SERVICE BULLETIN

SB98.4

Machines/Models: SP37

PURPOSE: Replace Slew Gear Box retaining hardware.

Figure 1

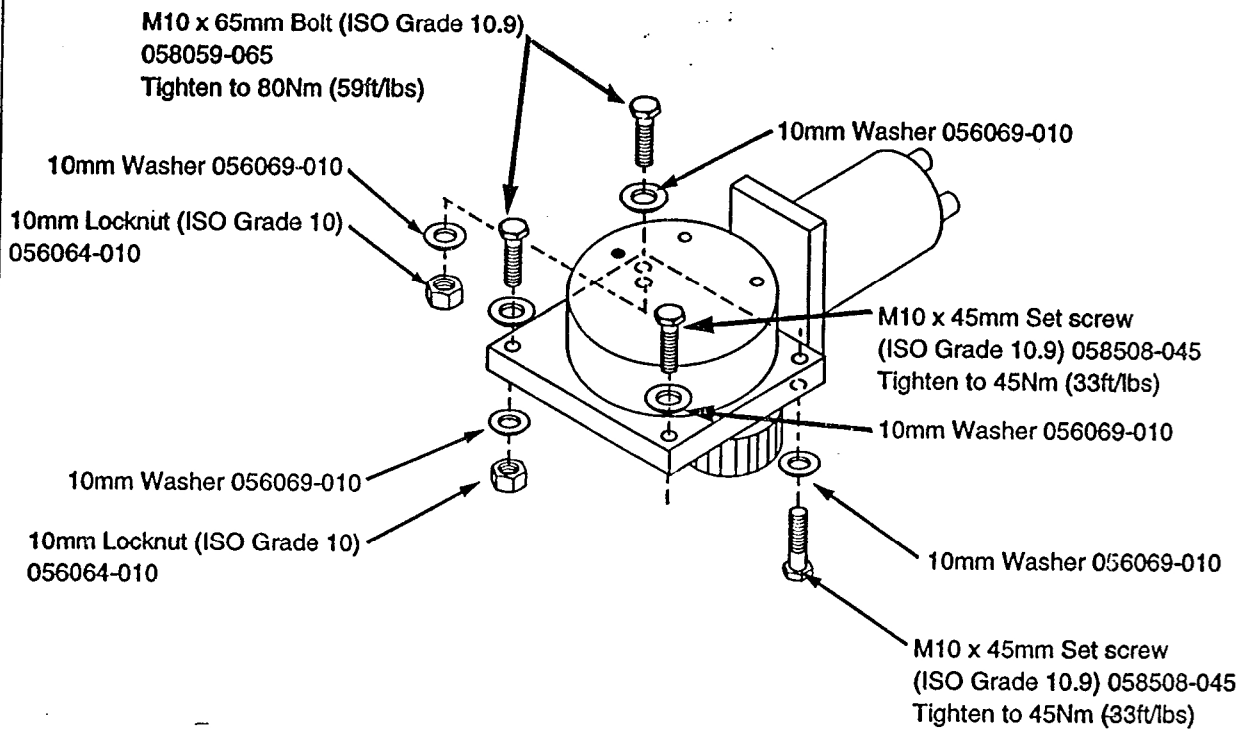
OPERATION REQUIRED: Remove existing hardware and replace with new.

1. Position machine on firm level surface with the platform in the stowed position.
2. Remove the four retaining bolts, washers and locknuts on the gearbox. See figure 1. Discard existing hardware.
3. Install supplied replacement retaining bolts, washers and locknuts as shown in figure 1.
4. Torque retaining bolts to the following ft/lbs. as listed in figure 1.
5. Perform a short cycle test on the Slew Gearbox to confirm that the procedure has been performed correctly by following steps 6 through 8.

PARTS REQUIRED: 2ea. #058059-065 - M10 x 65mm bolt (ISO Grade 10.9)
2ea. #058508-045 - M10 x 45mm set screw (ISO Grade 10.9)
6ea. #056069-010 - 10mm washers
2ea. #056064-010 - 10mm locknut (ISO Grade 10)
